SUBJECT: MCGUIRE NUCLEAR STATION, UNITS 1 AND 2 - STAFF ASSESSMENT OF INFORMATION PROVIDED PURSUANT TO TITLE 10 OF THE *CODE OF FEDERAL REGULATIONS* PART 50, SECTION 50.54(f), SEISMIC HAZARD REEVALUATIONS FOR RECOMMENDATION 2.1 OF THE NEAR-TERM TASK FORCE REVIEW OF INSIGHTS FROM THE FUKUSHIMA DAI-ICHI ACCIDENT (TAC NOS. MF3689 AND MF3690)

STAFF ASSESSMENT BY THE OFFICE OF NUCLEAR REACTOR REGULATION

RELATED TO SEISMIC HAZARD AND SCREENING REPORT

WMCGUIRE NUCLEAR STATION, UNITS 1 AND 2

Figure 3.3-1 Plot of Staff's and Licensee's Base Case Shear-Wave Velocity Profiles for the McGuire site

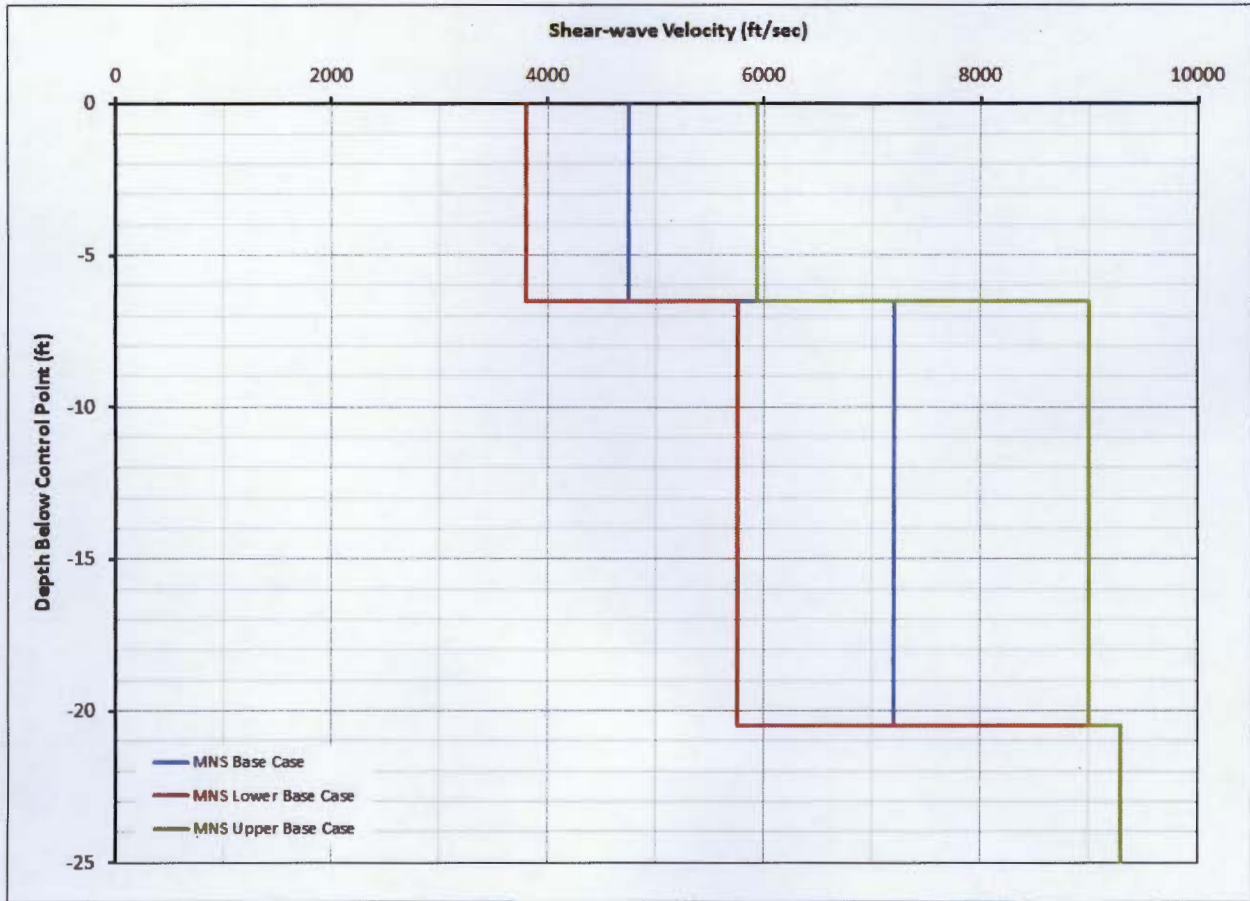
To characterize the uncertainty in the subsurface rock properties, the licensee developed three site base case profiles at the McGuire site. The licensee developed the upper and lower base case profiles by assuming a natural log standard deviation of 0.20 about the middle or best case

profile. Figure 3.3-1 of this assessment shows the licensee's three shear-wave velocity base case profiles for the McGuire site.

Figure 3.3-2 Plot Comparing the Staff's and the License's Median Amplification Functions and Uncertainties for two input loading levels for the McGuire site

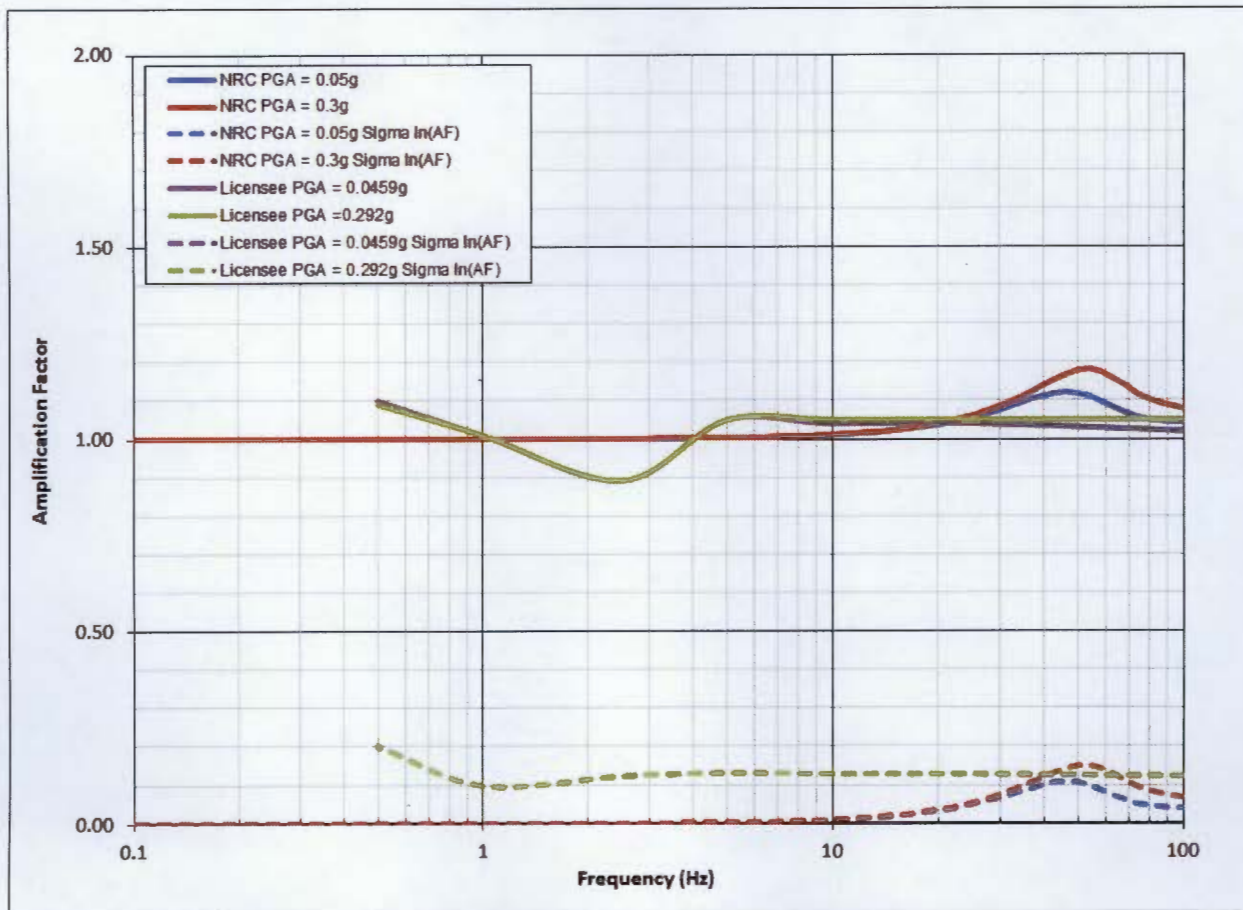
Figure 3.3-2 of this assessment shows a comparison of the NRC staff's and licensee's median site amplification functions and uncertainties (± 1 standard deviation) for two of the eleven input loading levels. Due to the use of very low damping values and modeling of the rock behavior as essentially linear for the range of input loading levels, the NRC staff's confirmatory amplification factors are essentially one for the entire frequency range. Although the licensee assumed non-linear behavior for the firm rock for the entire profile, as well as higher damping values to model the linear behavior, because the profile is relatively shallow, the licensee's amplification functions are also flat over the entire frequency range for the two loading levels shown in the SHSR.

Figure 3.3-3 Plot Comparing the Staff's and the Licensee's Mean Control Point Hazard Curves at a Variety of Frequencies for the McGuire site

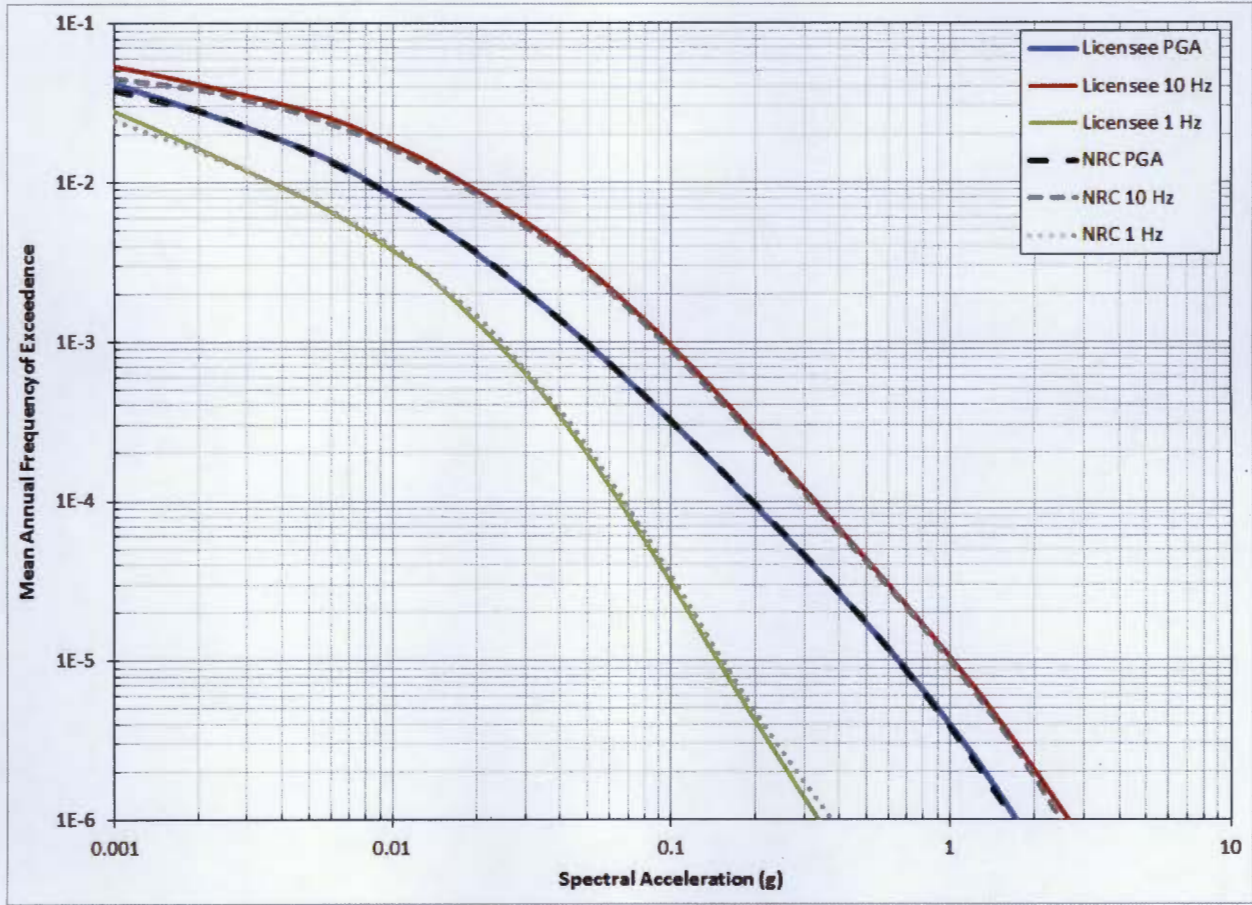
Overall, the licensee's approach to modeling the subsurface rock properties and to modeling their uncertainty results in similar amplification factors as those developed by the NRC staff. As shown in Figure 3.3-3 of this assessment, the NRC staff notes these differences in the site response do not have a large impact on the control point seismic hazard curves or the resulting GMRS, as discussed below. Appendix B of the SPID provides guidance for performing site response analyses, including capturing the uncertainty for sites with less subsurface data; however, the guidance is neither entirely prescriptive nor comprehensive. As such, various approaches in performing site response analyses, including the modeling of uncertainty, are acceptable for the 50.54(f) response.

Figure 3.4-1 Comparison of the Staff's GMRS with Licensee's GMRS and the SSE for the McGuire site

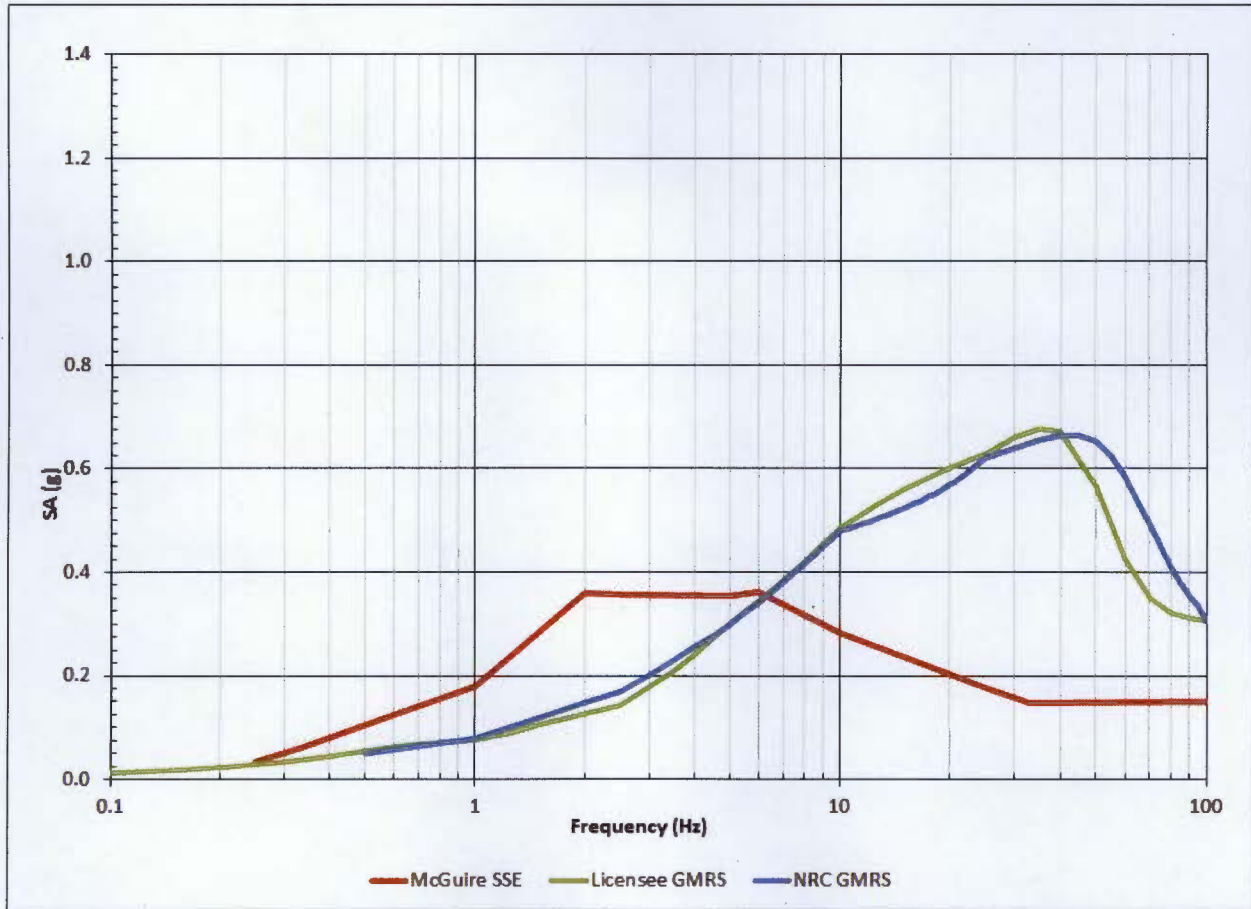
The NRC staff independently calculated the 10^{-4} and 10^{-5} UHRS using the results of its confirmatory PSHA and site response analyses, as described in Sections 3.2 and 3.3 of this staff assessment, respectively. Figure 3.4-1 of this assessment shows a comparison of the GMRS determined by the licensee to that determined by the NRC staff.

As shown in Figure 3.4-1, the licensee's GMRS shape is generally similar to that calculated by the NRC staff at frequencies less than 45 Hz. However, the NRC staff's confirmatory GMRS is somewhat higher than the licensee's at frequencies above 45 Hz. As described above in Section 3.3, the NRC staff concludes that these minor differences over the higher frequency range are primarily due to the differences in the site response analyses performed by the licensee and staff. The NRC staff concludes that the differences between the two GMRS are acceptable for this application because the licensee followed the guidance provided in the SPID with respect to both the PSHA and site response analysis for the McGuire site.

The staff confirms that the licensee used the present-day guidance and methodology outlined in RG 1.208 and the SPID to calculate the horizontal GMRS, as requested in the 50.54(f) letter. The NRC staff performed both a PSHA and site response confirmatory analysis, and achieved results consistent with the licensee's horizontal GMRS. As such, the NRC staff concludes that the GMRS determined by the licensee adequately characterizes the reevaluated hazard for the McGuire site. Therefore, this GMRS is suitable for use in subsequent evaluations and confirmations, as needed, for the response to the 50.54(f) letter.
